## THE POWERS VERTIGO TWPS HAS IMPROVED!

# Product Update

PU 0075

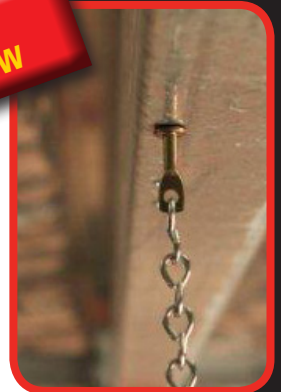
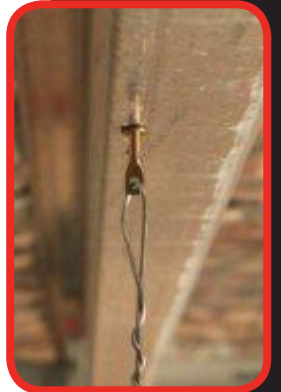
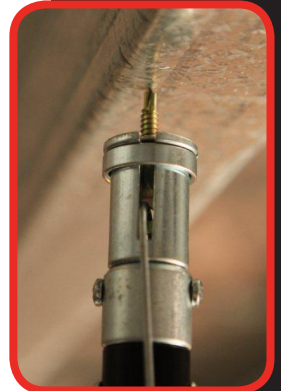
**This new version, the Vertigo TWPSN drills with ease into standard purlins up to 2.0mm and will also tackle lapped purlin joints.**

- **New Improved Pilot Point Drill Tip** - This allows the vertigo TWPSN to be installed in areas where the purlins join and overlap.
- **EPDM Washer** - for soft clamp effects eliminates risk of breaking from over tightening.

- **New Part number** - From now on when ordering - the new part number is TWPSN (Ezi find 511).
